NG-05-0594
10 CFR 50.90

Duane Arnold Energy Center
Docket 50-331
License No. DPR-49

Technical Specification Change Request (TSCR-074): "Elimination of Main Steam Line Radiation Monitor Trips"

Affected Technical Specifications: Section 3.3.6.1

Figure 1

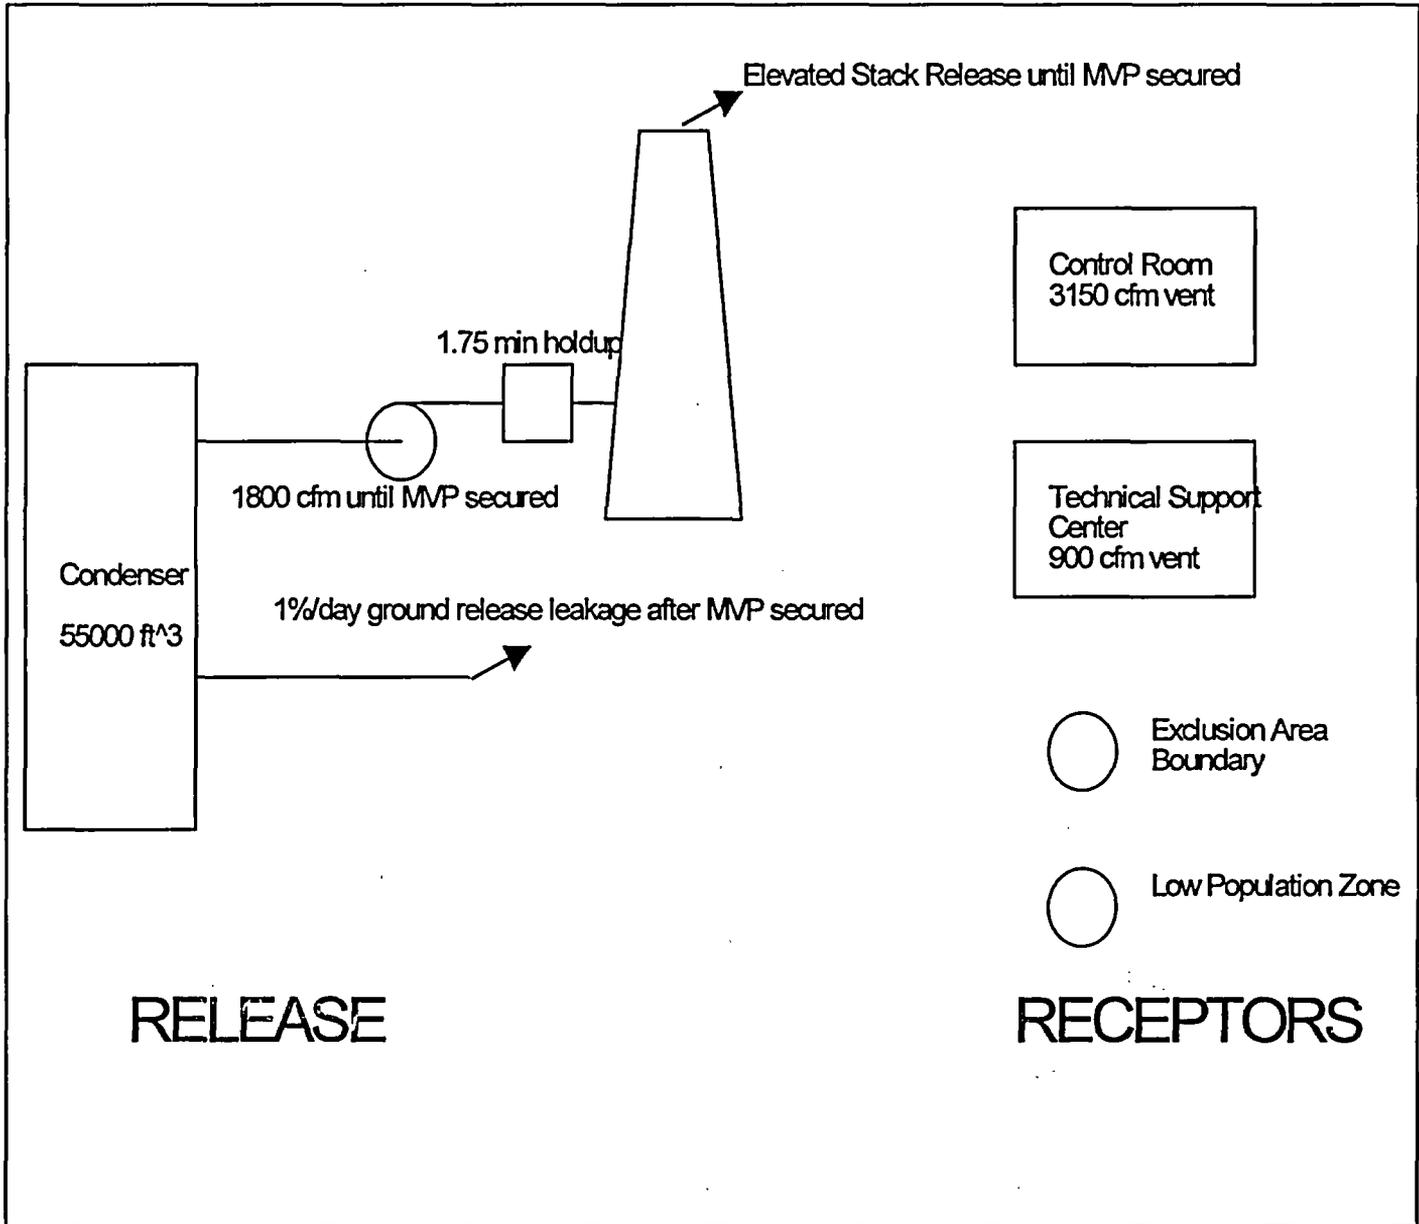
The basic model of the CRDA event is shown in Figure 1.

As a conservative assumption, the MSL drain flowpath to the condenser is not modeled and all the fission product release is transported directly to the turbine and condenser through the larger main steam piping. This maximizes the release, both in magnitude and timing, as the holdup in these drain lines is ignored.

In addition, the release path from the Recirculation Sample Valves is also not modeled, as any small system leakage would be into the Secondary Containment. Secondary Containment Integrity, Standby Gas Treatment System (SGTS) and

Secondary Containment Isolation Valves/Dampers (SCIV/Ds) are all required to be Operable by TS during plant startup (Modes 1 & 2). So, any leakage via the Recirculation Sample Valves pathway would be retained within the Reactor Building (Secondary Containment). A high radiation condition in the Offgas Stack, which would be expected during a CRDA with the MVP in operation, will result in a Secondary Containment isolation and initiation of the SGTS, as the Offgas Stack radiation monitor would normally be in service. If the Offgas Stack monitor is not in service, any significant radiation release in the Reactor Building would trip the building exhaust radiation monitors, which also cause a Secondary Containment isolation and initiation of SGTS. Thus, any release via this pathway would be an elevated, filtered release. Therefore, assuming all the fission products are released via the Condenser - MVP pathway is conservative, as this is not a filtered release.
